AMENDED BY CPC 1-24-91  
AMENDED BY STAFF 1-24-91  
**CITY PLANNING COMMISSION**  
1231 "I" STREET, SUITE 200, SACRAMENTO, CA 95814

- APPLICATION:**
- A. Negative Declaration
  - B. Tentative Map to subdivide 25± partially developed acres into 87 single family and 36 halfplex lots in the Standard Single Family (R-1) and Rural Estates (RE) zones

**LOCATION:** Rose Street, near Rio Linda Boulevard

### TENTATIVE SUBDIVISION MAP

## EXHIBIT A

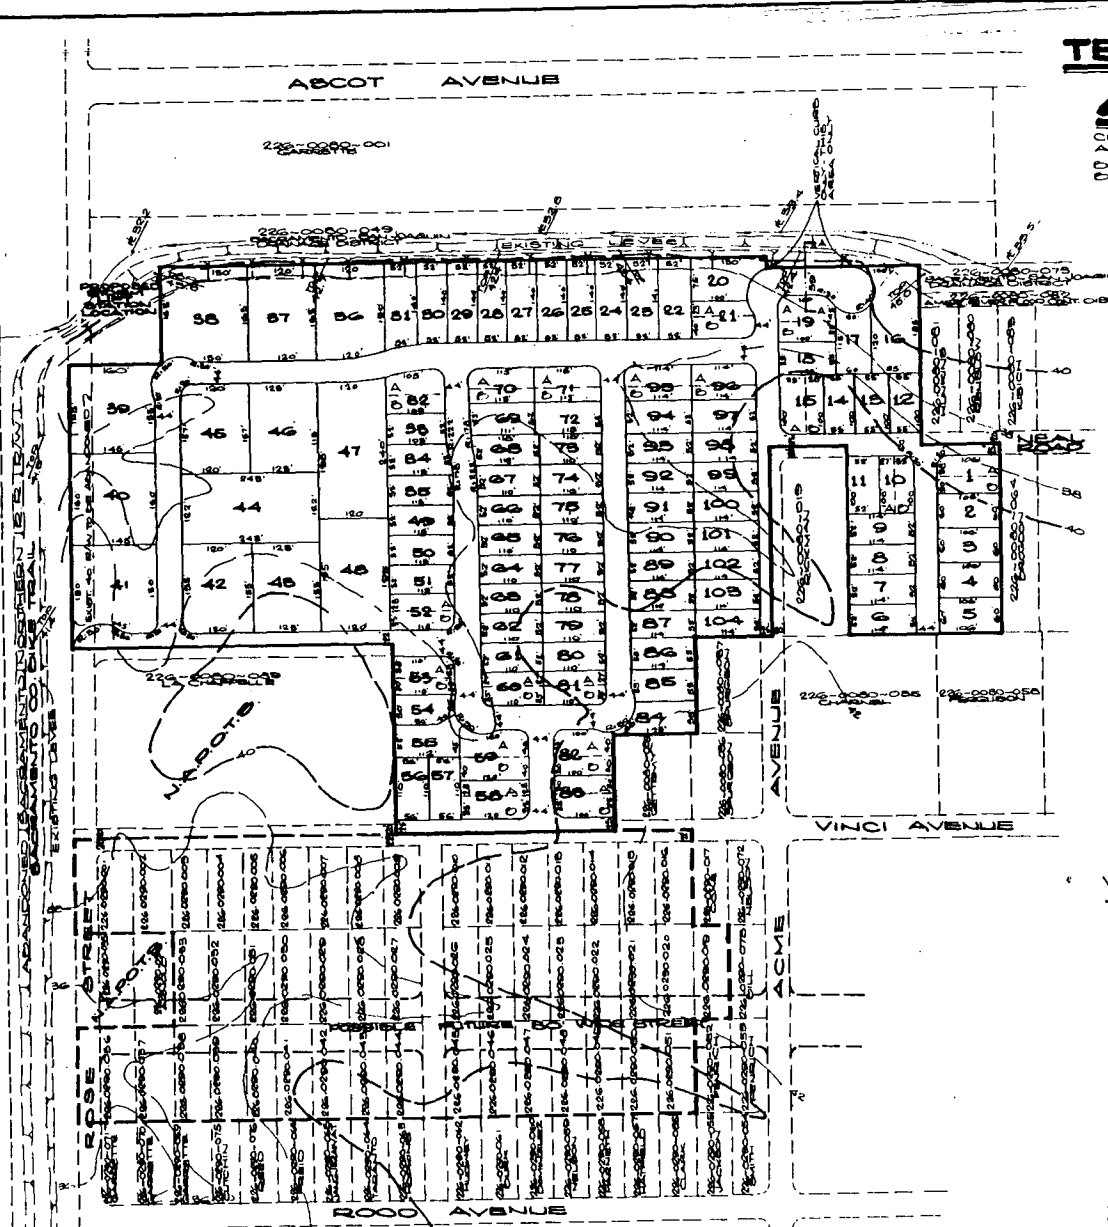
The applicant is proposing to subdivide 25± acres into 87 single family and 36 halfplex lots in the Rural Estates, RE (1du/.5 na), and Standard Single Family, R-1, zones (see Exhibit A). The applicant proposes extending Acme Avenue and Vinci Avenue to provide access to the proposed subdivision streets. The original subject site included the future development on the block bounded by Acme Avenue, Vinci Avenue, Rose Street, and Rood Avenue. These lots are already subdivided so that portion of the subject site was deleted. Thirteen lots, Lots 36 through 48 are in the Rural Estates, RE (1 du/.5na), zone. Eighteen corner lots, Lots 1, 10, 15, 19, 21, 32, 52, 53, 58, 59, 60, 70, 71, 81, 82, 83, 95, and 96 are proposed for halfplex development. Magpie Creek drainage canal is located to north of the-subject site and the bike trail located on the levee of the abandoned Sacramento Northern Railroad right-of-way is to the west.

The subject site consists of eleven lots totaling 25± gross acres in the Rural Estates, RE (1 du/.5 na), and Standard Single Family, R-1, zones. The applicant is proposing to subdivide the 6.6± acre portion of the site in the Rural Estates zone into 13 lots with a density of 2 du/na. The applicant is proposing to subdivide the 13.7± acre portion of the subject site in the R-1 zone into 110 lots, including 36

halfplex lots, with a density of 8 du/na. All of the lots in the R-1 zone meet the required minimum standard lot area, width and depth. Each lot in the proposed subdivision must meet the R-1 setback requirements in order to provide adequate yard areas for each lot. The proposed lot configuration provides a logical relationship between the subject site and the existing and future streets. A cul-de-sac at the northeast corner of the site will be available for access to the Magpie Creek drainage canal.

11. *The following streets should be City standard 50 foot right-of-way streets: Acme Avenue, Vinci Avenue, and Neal Road. (Staff deleted 1-24-91)*
12. Minimum 120 foot offset is required between street adjacent to lots #58 and 59 and street adjacent to lots 60 through 70.

21. *The applicant shall provide a temporary hammerhead to the satisfaction of the Traffic Engineer on the street stub between lots 5 and 6. (Staff added 1-24-91)*

22. *Due to possible negative impacts of the Rio Linda Airport, Lots 36 through 48 will be deleted from this Tentative Map request. (Staff added 1-24-91)*

23. *The applicant shall provide a cul-de-sac at the street stub between lots 31 and 32A to the satisfaction of the Traffic Engineer. (Staff added 1-24-91)*

24. *The applicant shall provide an adequate barrier at the street stub between lots 52 and 53 to the satisfaction of the Traffic Engineer. (Staff added 1-24-91)*

**EXHIBIT B**

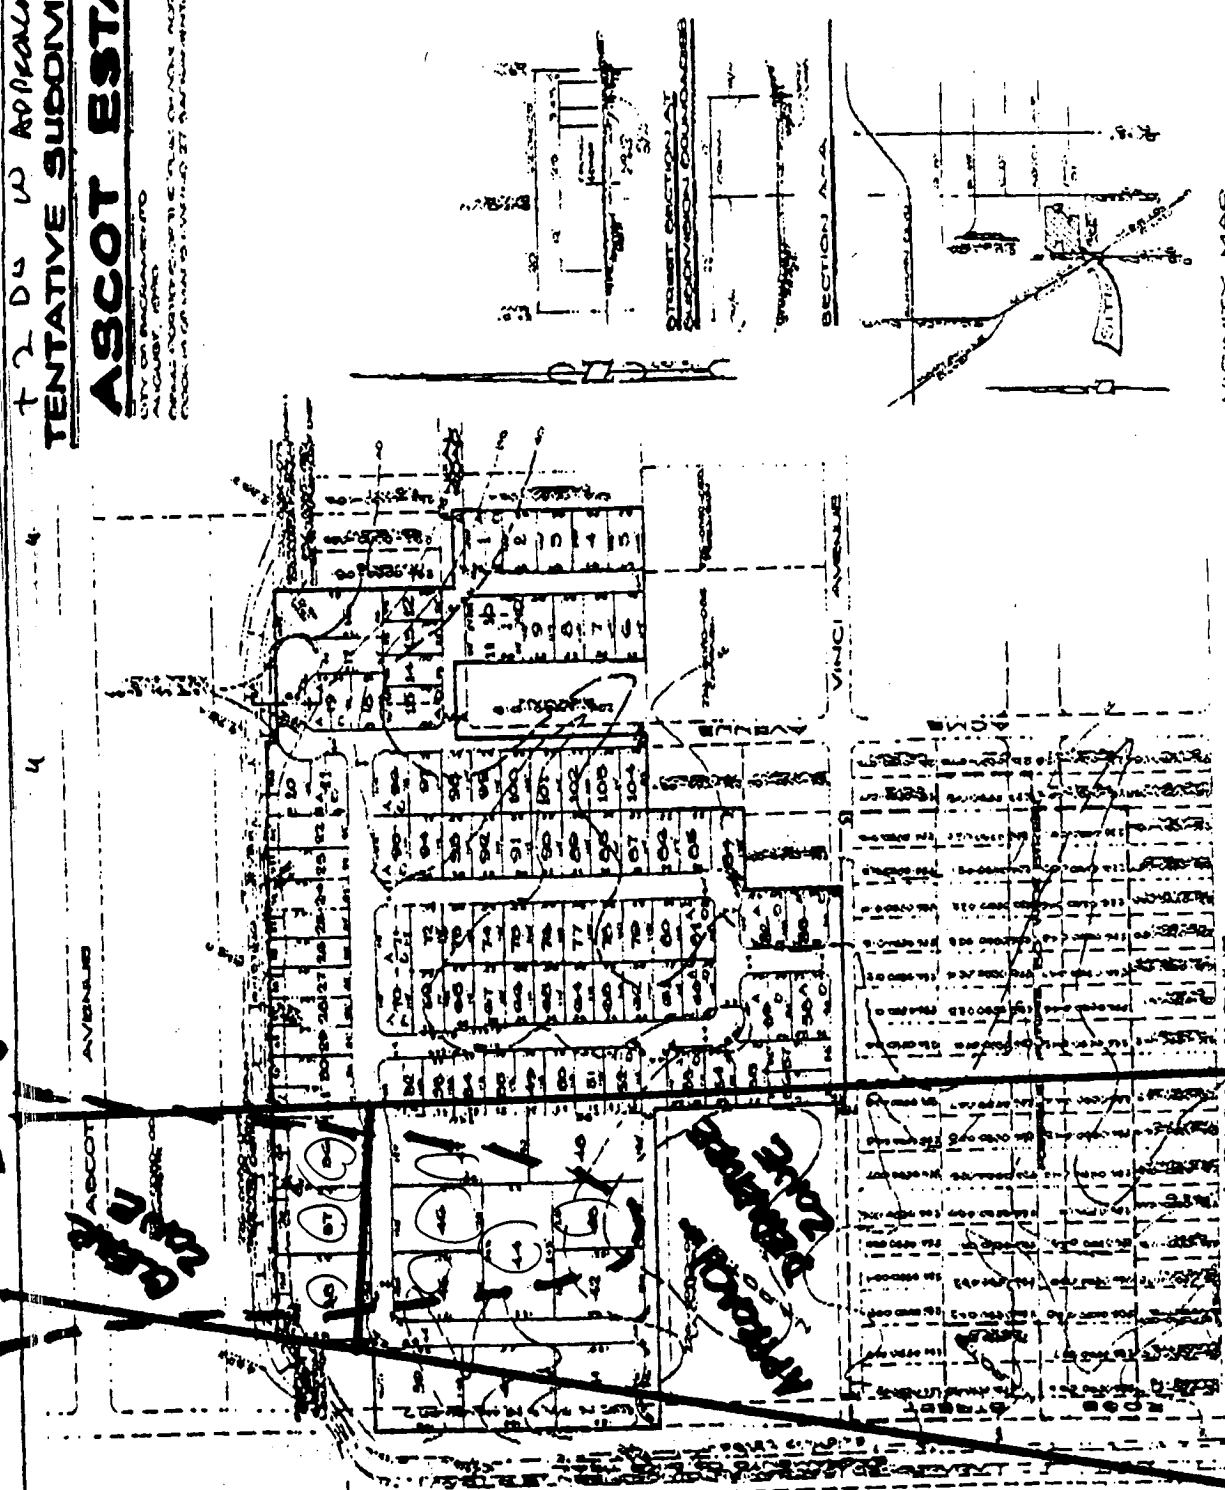
*The Rural Estates portion of the subject site is within the boundaries of the Rio Linda Airport Clear Zone and the Approach- Departure Zone and a portion of the site exceeds 65 CNEL noise levels (see Exhibit B). No structures are allowed in the Clear Zone or the Excessive Noise Area without approval from the City Council. Approximately eight lots in the RE zone would not comply with these restrictions. The applicant has agreed to delete the Rural Estates portion of the subject site from this Tentative Map application. Further analysis of the impacts of the Rio Linda Airport would be required prior to any approval of a tentative map for the Rural Estates zoned area. (Staff added 1-24-91)*
